NORTHEAST UTILITIES

Docket No. 50-213
B14507

Haddam Neck Plant
Proposed Revision to Technical Specifications
Reactor Coolant Pump Flywheel Surveillance

FIGURE 1 FLYWHEEL AREAS/PARTS

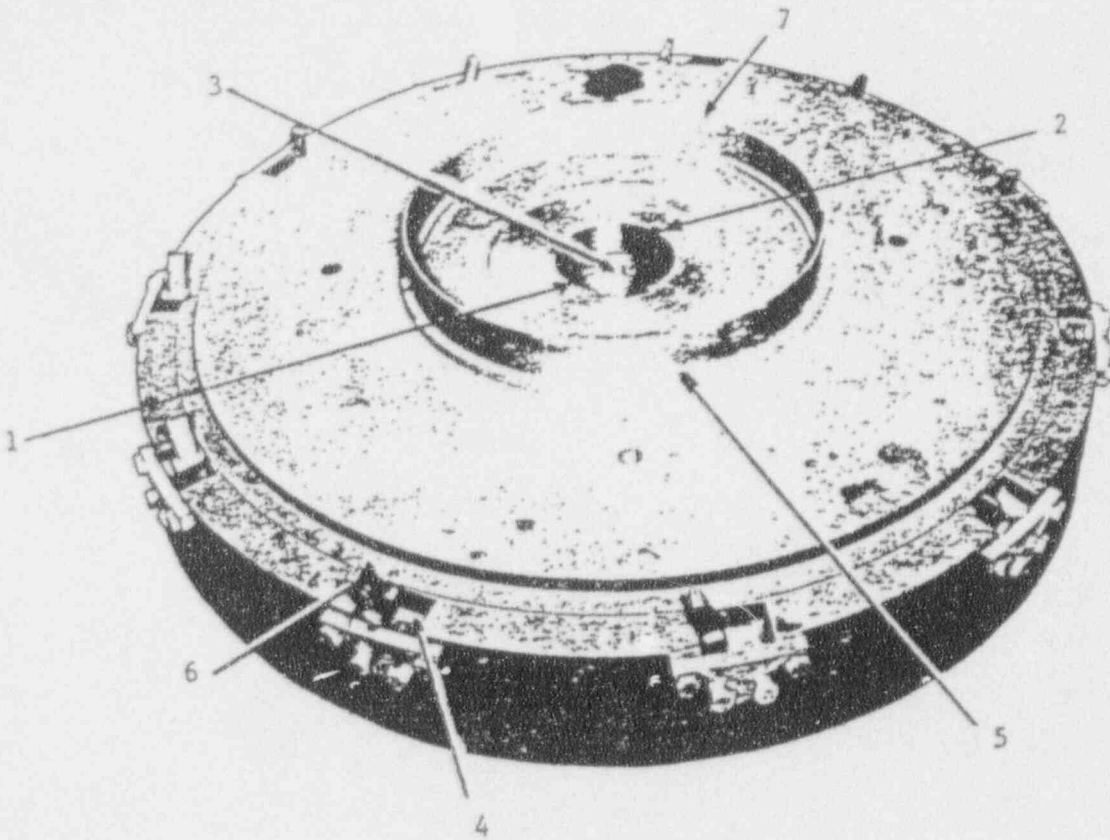
Currently, Technical Specification Surveillance Requirement 4.4.10 identifies Regulatory Guide (RG) 1.14,⁽¹⁾ as providing the criteria for the inspections of the reactor coolant pump (RCP) flywheels at the Haddam Neck Plant. This RG recommends volumetric and surface examinations on different areas of the RCP flywheels at varied inspection frequencies. In order to satisfy these recommendations, CYAPCO has established an examination schedule which requires that at least two flywheels be examined during each refueling outage. An illustration of the RCP flywheel is provided in Figure 1 for your information. This figure details both critical and noncritical areas of the RCP flywheel.

"the areas of higher stress concentration at the bore and keyway of each reactor coolant pump flywheel shall be ultrasonically examined at least once during each 10-year inspection interval. Scheduled examinations shall not exceed any 10-year period of operational service."
